SUBJECT: Forwards results of Westinghouse rept re boron injection tank (BIT) concentration/elimination study, in support of request to reduce BIT boron concentration to 0 ppm. Change would eliminate heat tracing, reducing maint costs.

SHEARON HARRIS NUCLEAR POWER PLANT
UNIT NO. 1 - DOCKET NO. 50-400
BORON INJECTION TANK CONCENTRATION REDUCTION

RESULTS OF THE REPORT FOR THE
BIT CONCENTRATION REDUCTION/BIT ELIMINATION STUDY
FOR THE SHEARON HARRIS NUCLEAR POWER PLANT

FIGURE 1

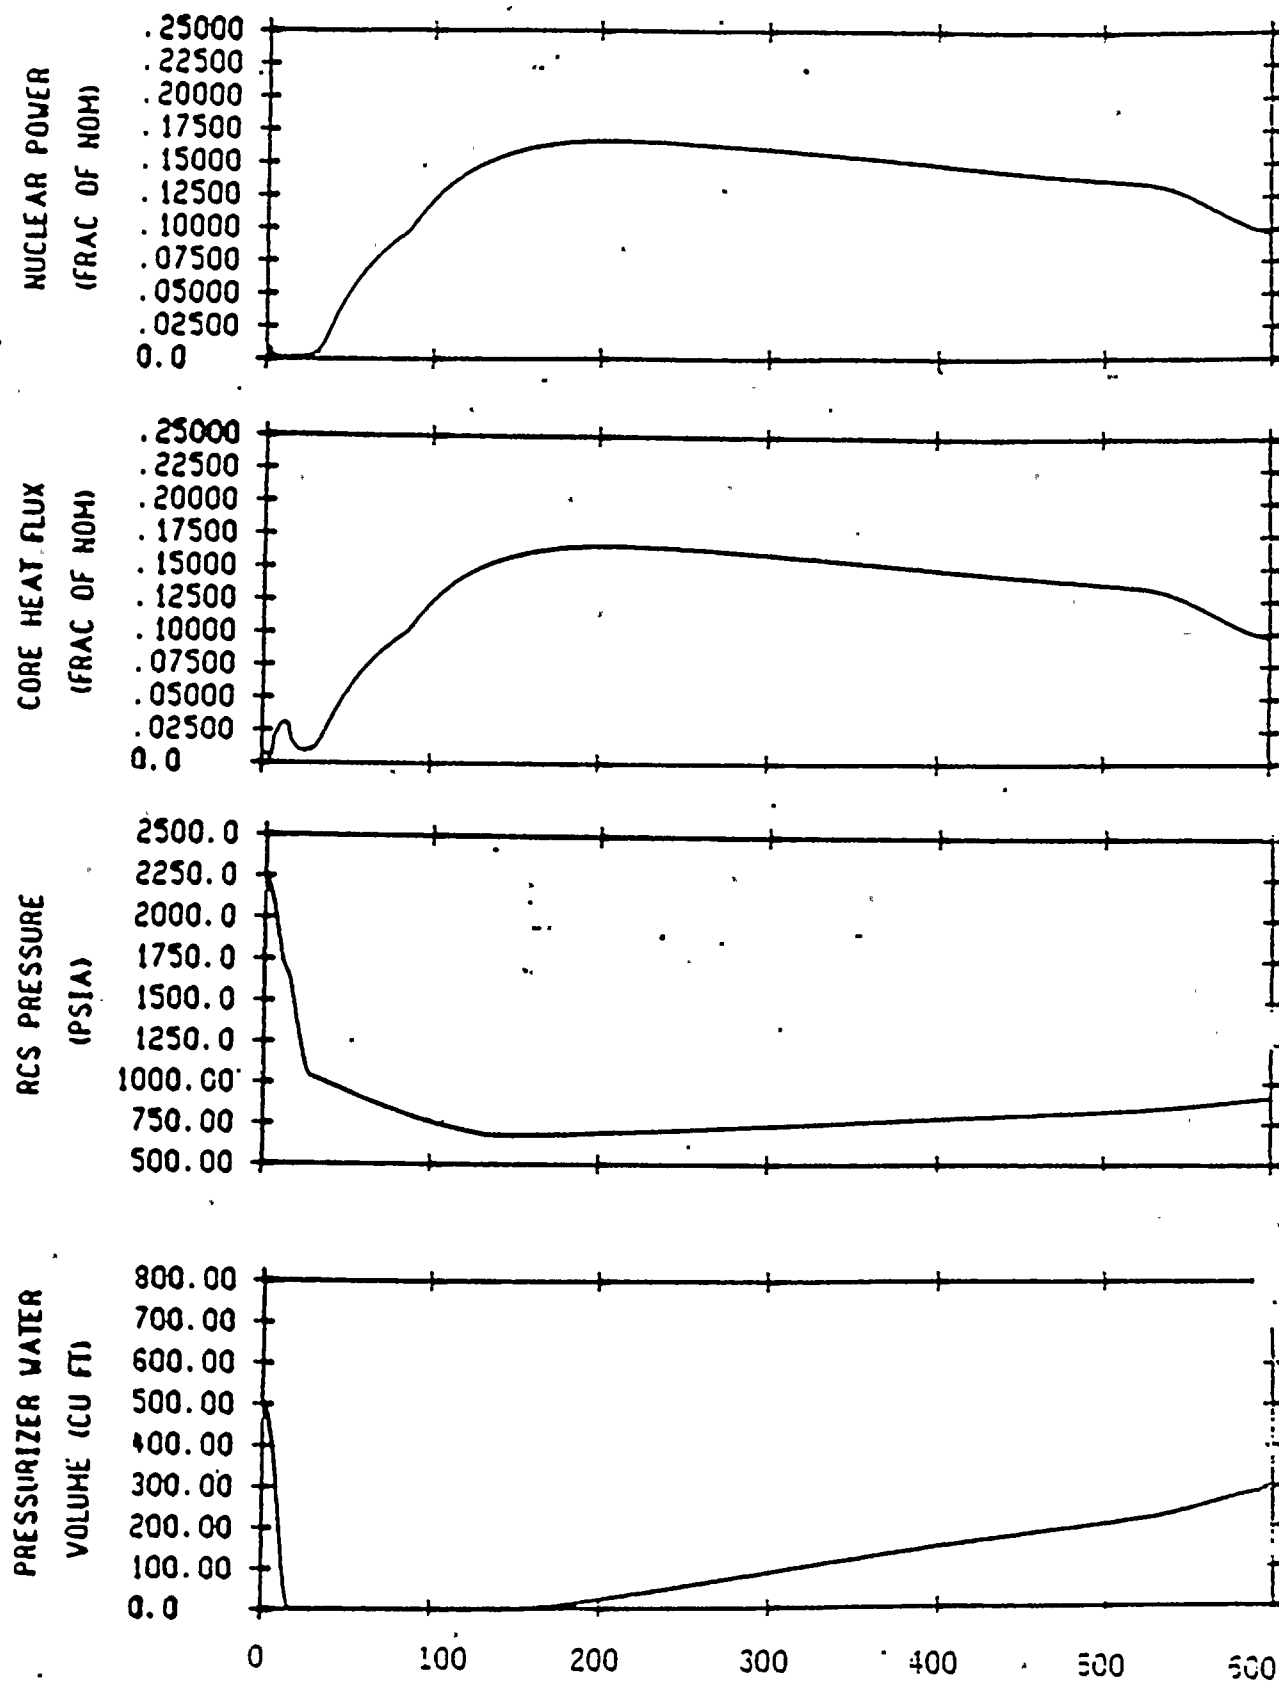
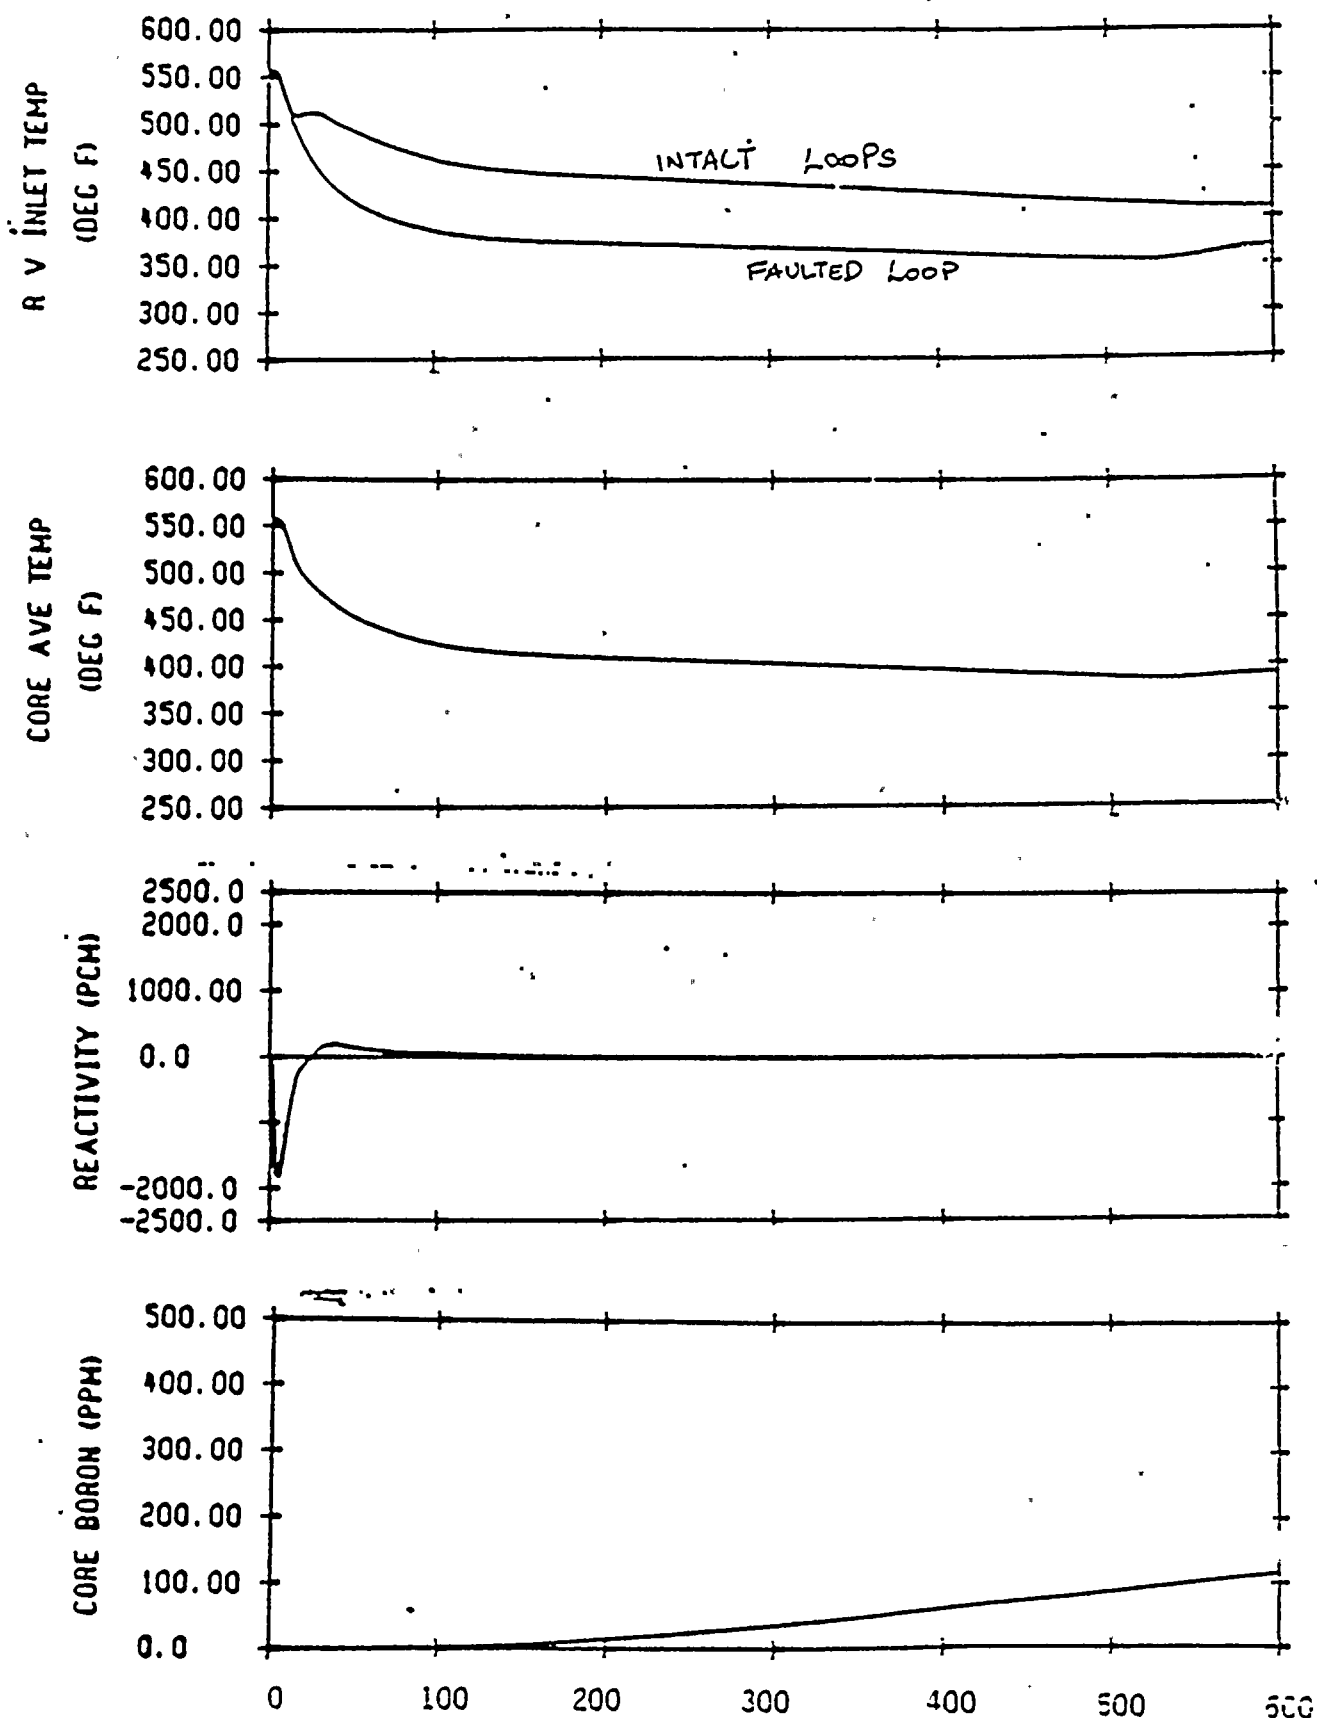
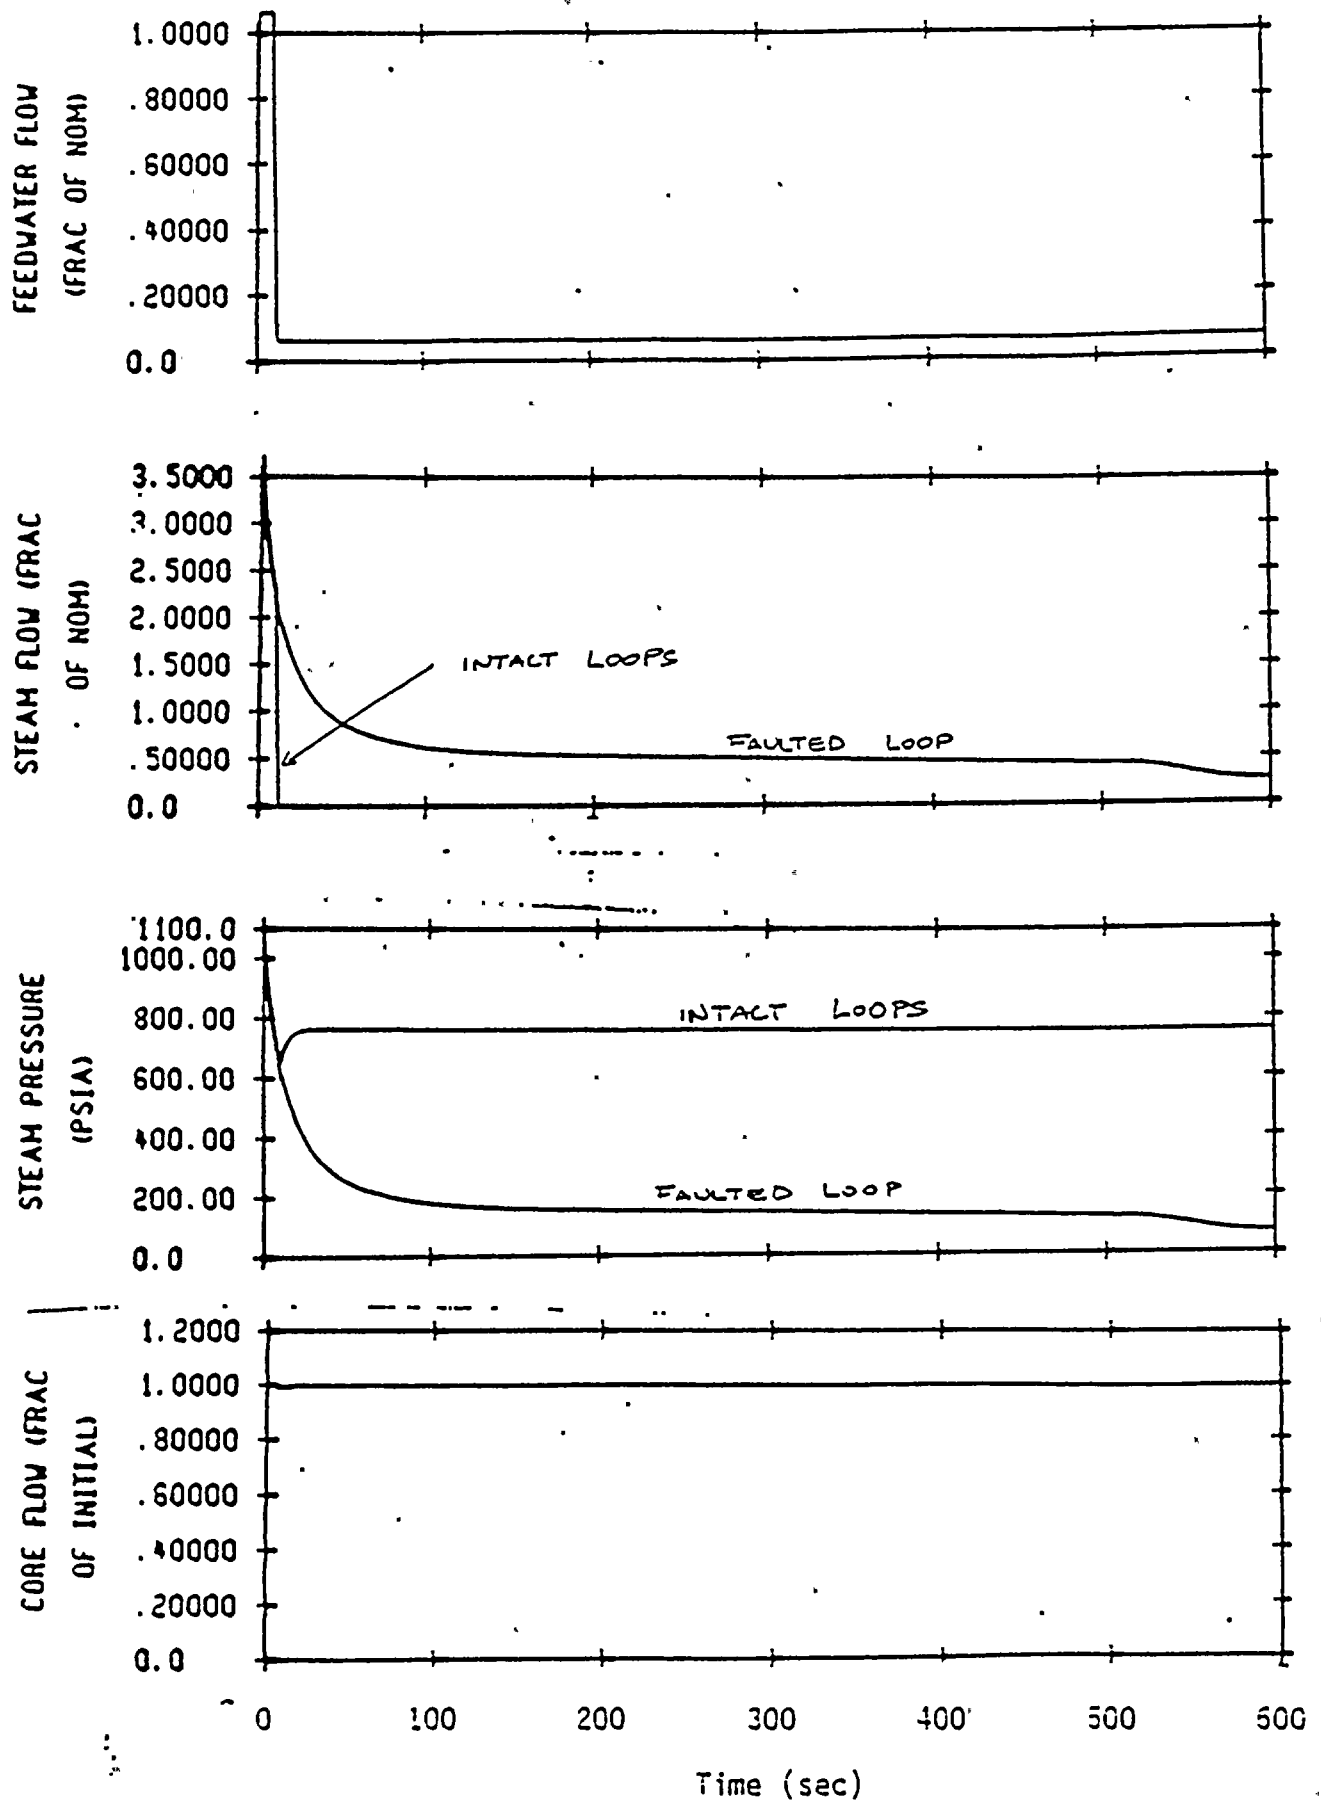
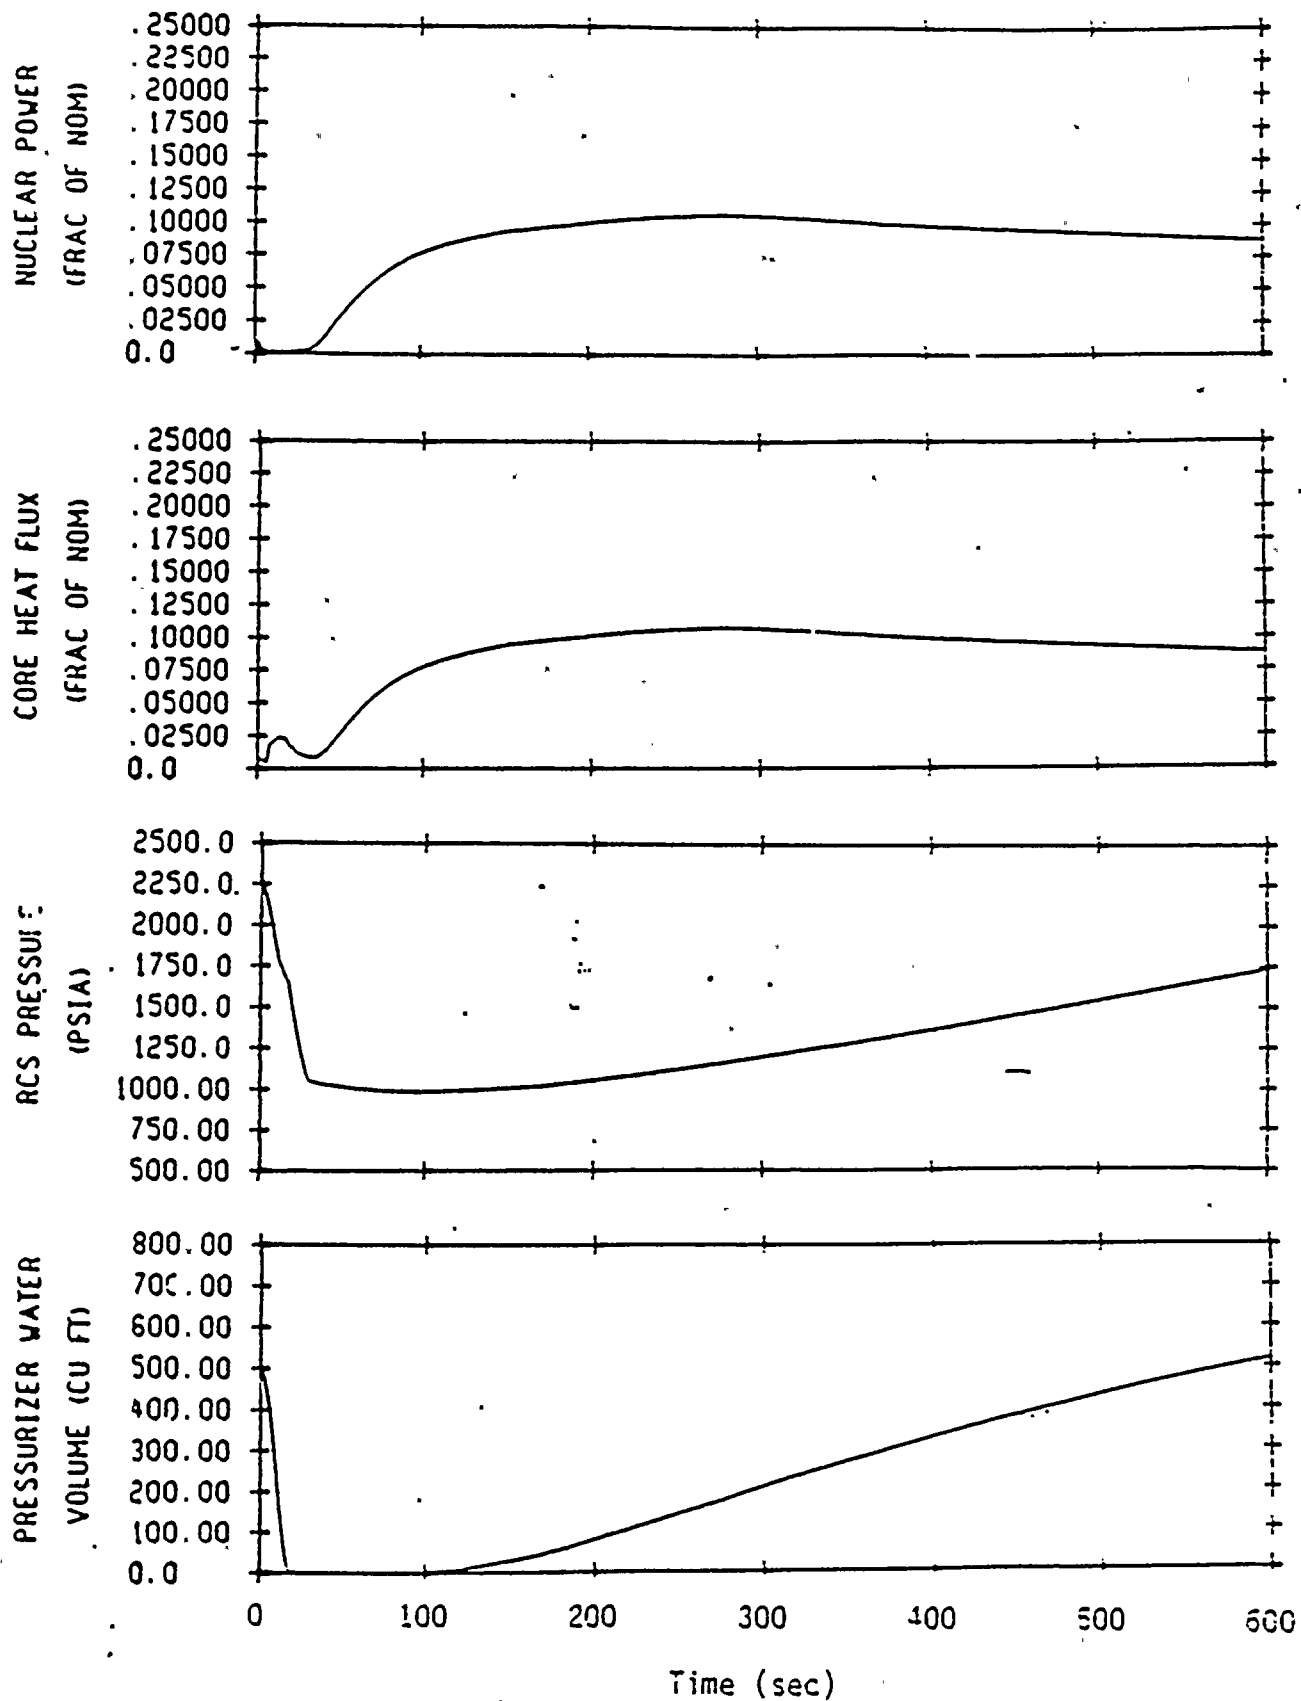
The attached Figures 1 through 6 show the transient behavior for the hypothetical breaks. A comparison of these figures with the current FSAR figures reveals only small changes in RCS parameters, with the single exception of core power, which is understandably higher for the cases without the BIT. The effect of the boron on the total reactivity is both delayed and damped in the attached figures because the Safety Injection System must purge more water before injecting boron in the cold leg and the fact that the boron source (RWST) is both colder and of a lower boron concentration. This causes the power to initially rise to a higher peak due to the delay and to subsequent decay at a slower rate after the boron reaches the core. Additionally, with the BIT assumed to be at zero ppm concentration, the BIT acts as a dilution volume for the borated water being injected from the RWST, thereby further delaying the effectiveness of the RWST.
